May 3, 2023

Re: Rezoning from R-4 to PEC for Industrial Distribution Facilities (the “Xebec Development”)
Tracts comprising 73.43 acres on Tucker Station Road / Pope Lick Road (collectively, the “Property”)
Xebec Pursuits, LLC (“Xebec”)
22-ZONE-0098

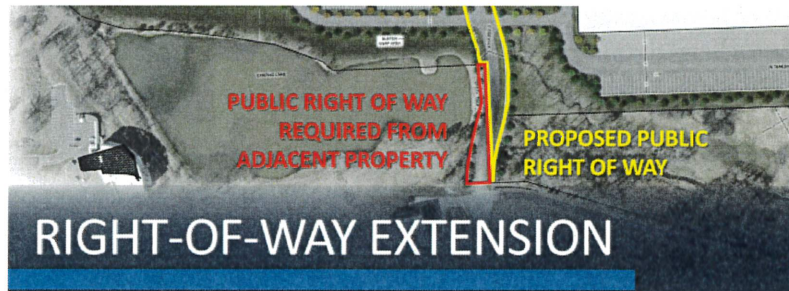
- 2) Does Xebec have a conceptual plan (alignment/profile) of how the proposed Schutte Station Place will be constructed? This has been requested numerous times by the Planning Commission with only an engineer letter opining that a connection to Schutte Station Place is technically feasible having been provided to date. The Xebec LD&T presentation indicates additional right-of-way is required from the Association and/or the adjacent business owner in order for the connection at Schutte Station Place to be completed (pasted below), but no agreements have been reached with the Association or the adjacent business owner:
